**DEPARTMENT OF LABOR**

**29 CFR Part 1910**

**Walking-Working Surfaces, Personal Protective Equipment (Fall Protection Systems), and Special Industries (Electric Power Generation, Transmission, and Distribution); Corrections**

**ACTION:** Final rule; corrections to standards.

Figure D-8 – Dimensions of Standard Stairs

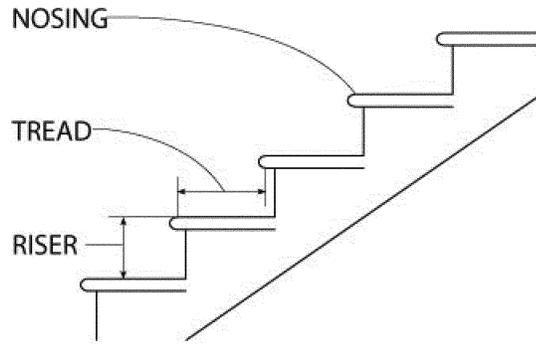
The figure at 29 CFR 1910.25(c) immediately after Table D-1 does not have a title even though it is referred to as Figure D-8 in § 1910.25(c)(4). The title of the figure was included in the proposed rule (75 FR at 29137) but mistakenly left out of the final rule (81 FR at 82989). This document adds the missing title to the figure: “Figure D-8—Dimensions of Standard Stairs”.

MINIMUM TREAD WIDTH 22 IN (56 CM)  
 MINIMUM TREAD DEPTH 9.5 IN (24 CM)  
 MAXIMUM RISER HEIGHT 9.5 IN (24 CM)

Figure D-11 Guardrail Systems

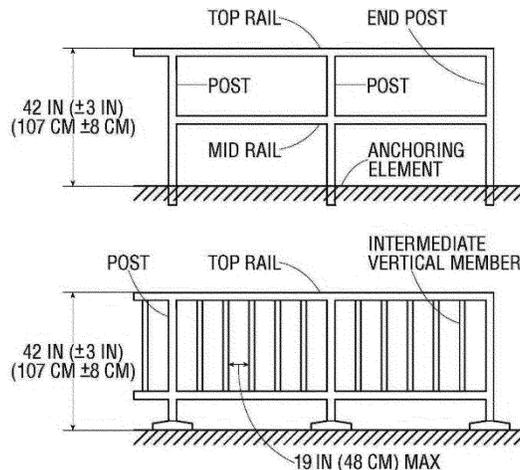
OSHA is correcting Figure D-11 to include labels identifying the top rail and end post in the top diagram of the figure. The words “top rail” and “end post” were mistakenly omitted when the final rule was published in the **Federal Register** (81 FR at 82995).

(1) The top edge height of top rails, or equivalent guardrail system members, are 42 inches (107 cm), plus or minus 3 inches (8 cm), above the walking-working surface. The top edge height may exceed 45 inches (114 cm), provided the guardrail system meets all other criteria of paragraph (b) of this section (see Figure D-11 of this section).
